Fort Lauderdale Police Headquarters

WJE Peer Review, Phase 1 - North Elevation Evaluation

December 31, 2024
WJE No. 2024.4855.0

Figure 13. Detail 6 from Sheet HQ-S5-1-03 dated May 24, 2024, showing section through column enlargement rectification for third story columns at gridlines H-2 and J-2.

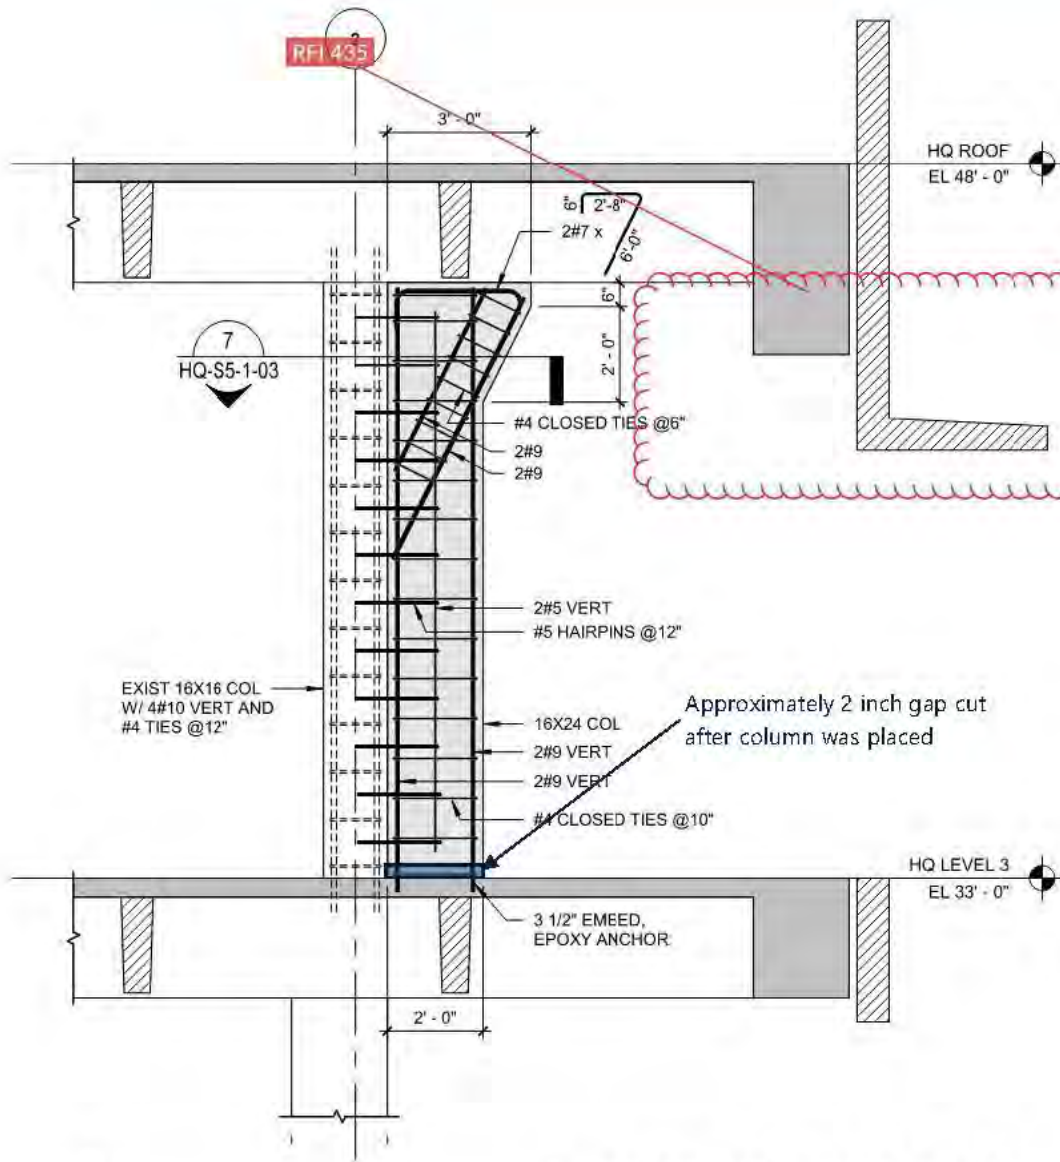
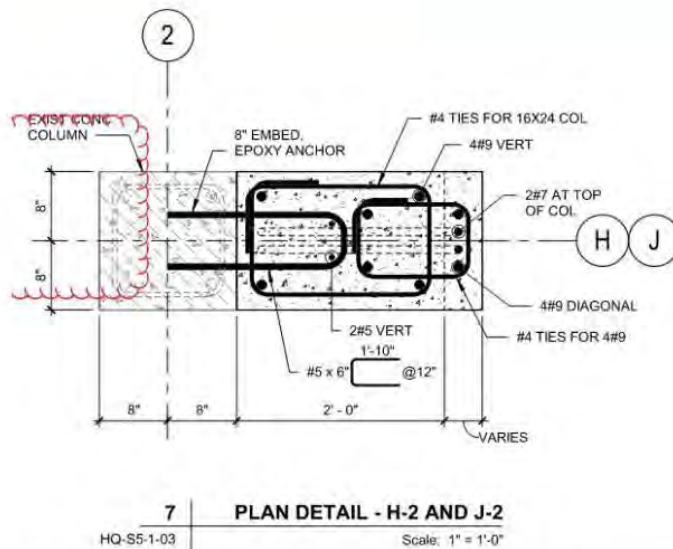
The column enlargement and corbel at the top of the enlarged column are connected to the original column with "U"-shaped No. 5 bar stirrups at 12 inches on center (see Figure 12 and Figure 13). While this distributed connection "stitches" the two columns together, it is our opinion that these "U"-shaped stirrups do not sufficiently resolve the horizontal force that is developed as a result of the inclined "strut" in the corbel. To sufficiently resolve the horizontal force, a tie that spans from the north side of the corbel to the south side of the original column is appropriate. Lakdas also suggested such a tie in their report (Figure 87). This tie should be designed for the horizontal component of the maximum diagonal strut force that is determined through staged-construction analysis. Long-term load-transfer effects due to creep should be considered in the design.

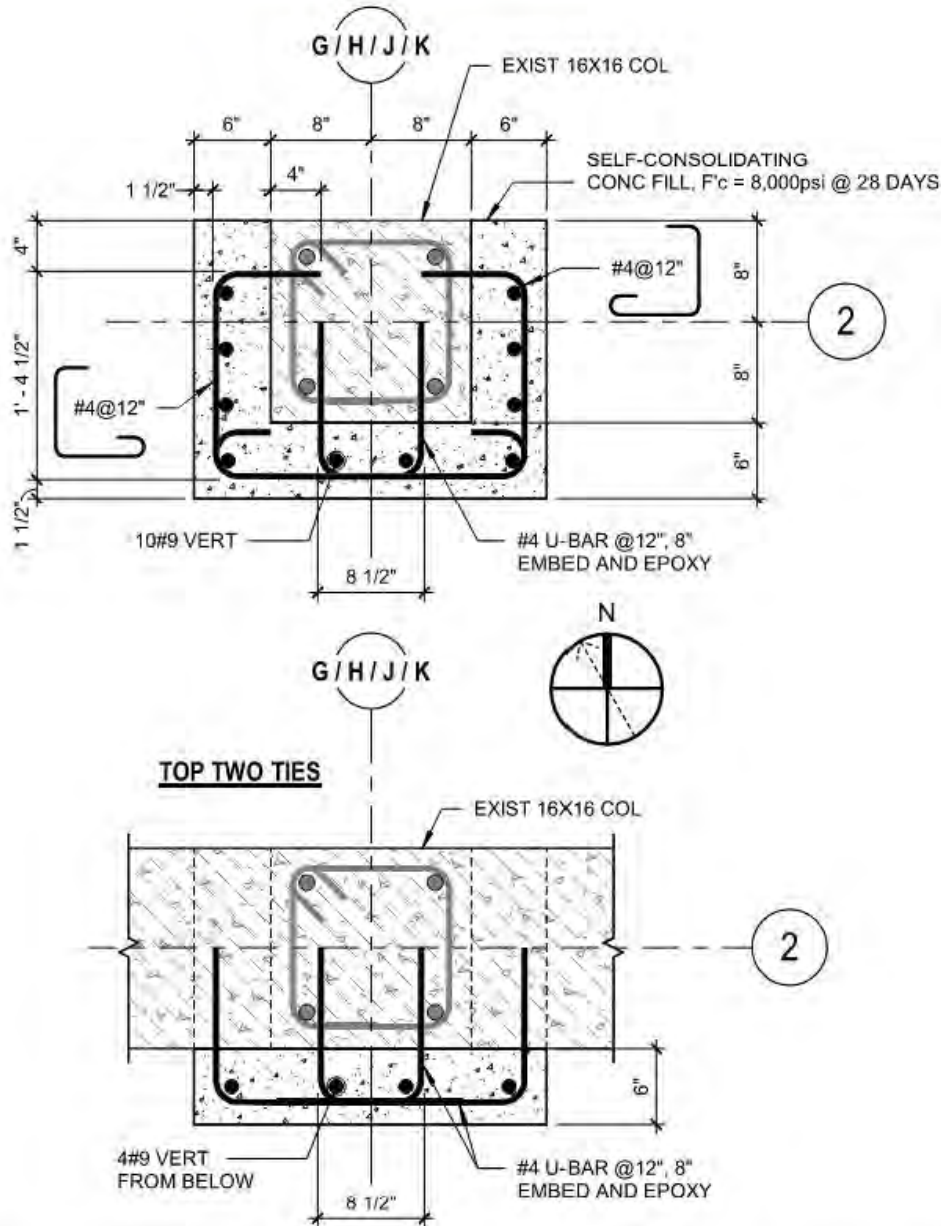
That said, we have some reservations about how the column jackets will be implemented. Currently, the ties for the column jacket (Figure 18), have their termination on the northern side of the column, embedded 4 inches into the column using epoxy adhesive. Terminating the tie in this manner will not

provide a closed tie. Closed ties will provide a more reliable means of restraining and bracing the flanges of the column bracket and will also serve to provide additional confinement to the original column. We recommend that the tie detail be modified such that a closed tie can be provided. One possible option to achieve a closed tie is shown conceptually in Figure 85.

Figure 79. Conceptual rectification for partial re-grouting of base of column enlargement

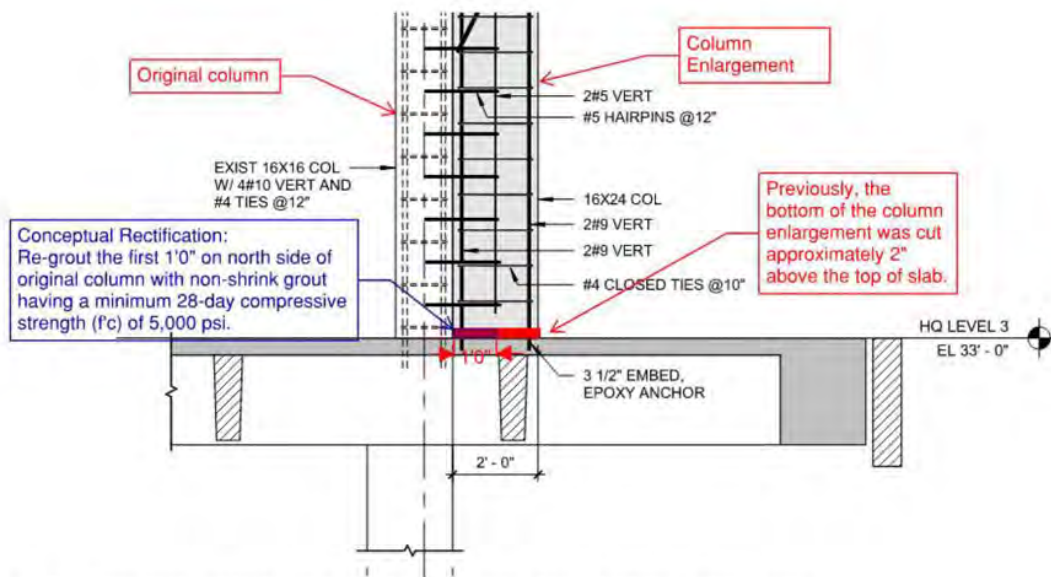
- This result is due to the condition at the base of the column where the column enlargement was demolished in combination with the biaxial bending in the column. If 12 inches of the column enlargement are grouted (see Figure 79) with non-shrink grout having a minimum 28-day compressive strength of 5,000 psi, then the column would be code-compliant for strength for axial plus biaxial bending.

must be resisted by the original column. We determined that once the enlargement was added and then the lower portion removed, the remaining original column cross-section is no longer code-compliant for axial plus biaxial bending due to the cut but could be brought back into compliance if 12 inches of the base of the column are regouted (see Figure 79).

Figure 82. Calculations of cantilever beam shear capacity at gridlines H-2 and J-2 by SEOR (from File 2024-04-25_CALC_HQ Roof Cantilever Field Fix at North Elevation.pdf) showing assumption of including shear friction of bars in bottom side (compression side) of the beam.

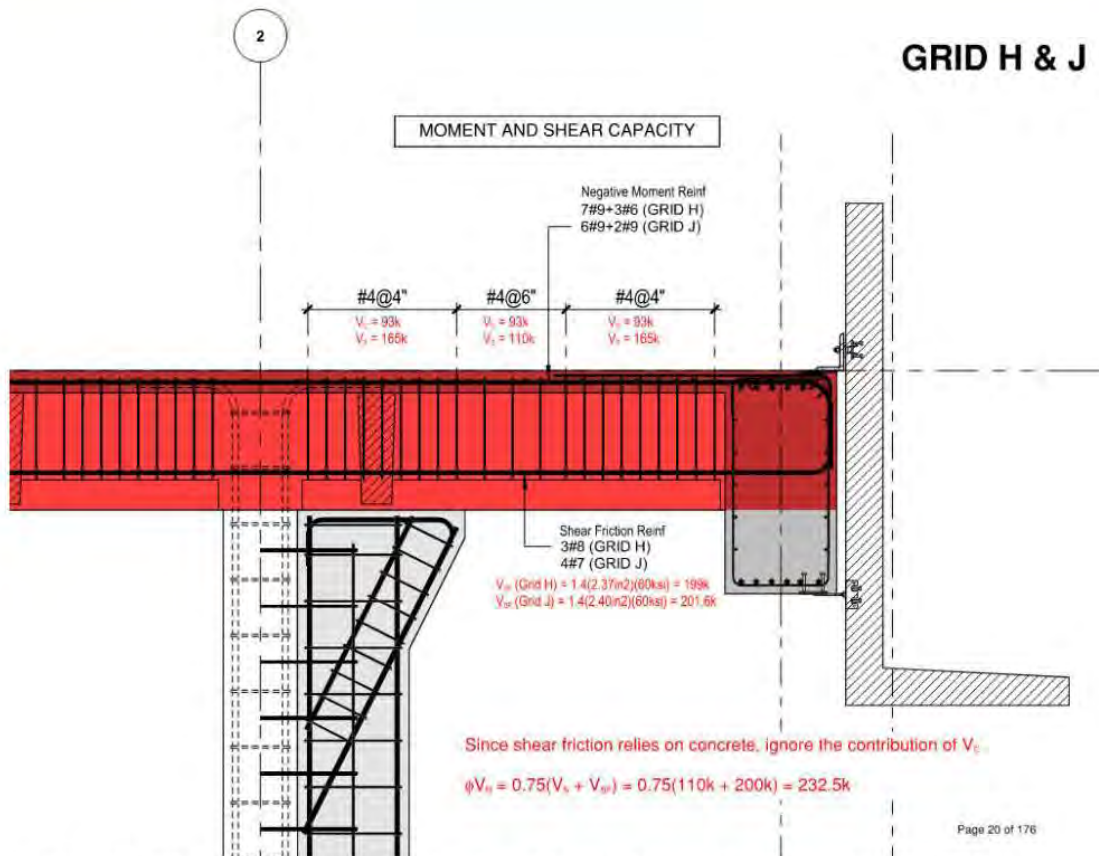
beam stirrups acting in a classical strut and tie shear resisting mechanism plus shear friction resistance that relies on longitudinal steel on the bottom side of the beam just above the precast soffit (Figure 82). However, in our understanding of the ACI provisions for beam shear and our experience⁴, combining shear friction resistance with classical strut and tie resistance to calculate the total sectional shear capacity of any beam is neither appropriate from a mechanics perspective nor permitted by ACI.

Figure 83. Conceptual solution for strengthening of cantilever roof beams.

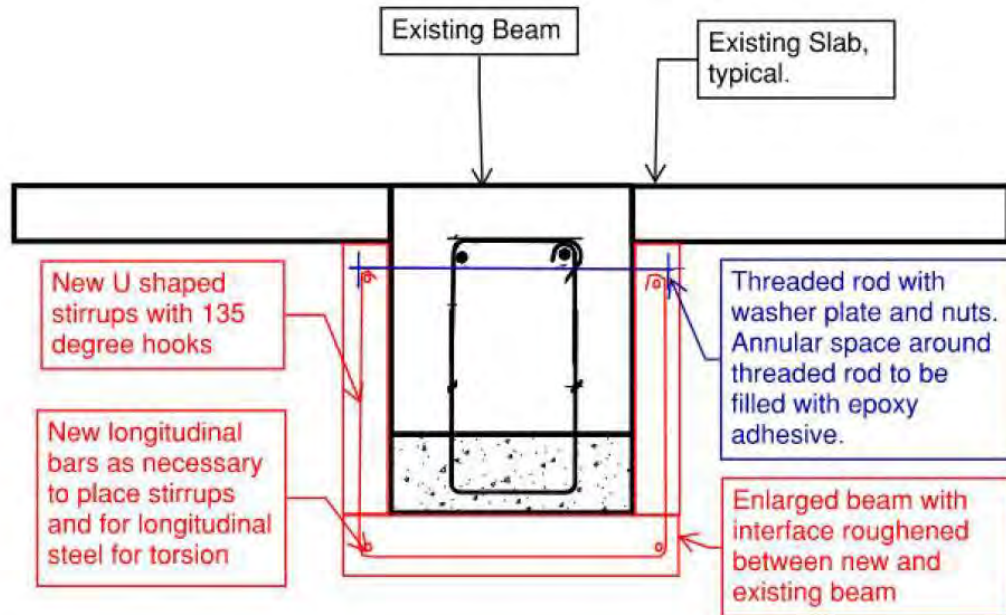
In our opinion the beam sections north of the column enlargement (i.e., along gridlines H-2 and J-2), need to be strengthened. Strengthening could be accomplished through the addition of a beam jacket with closed stirrups (e.g. Figure 83).
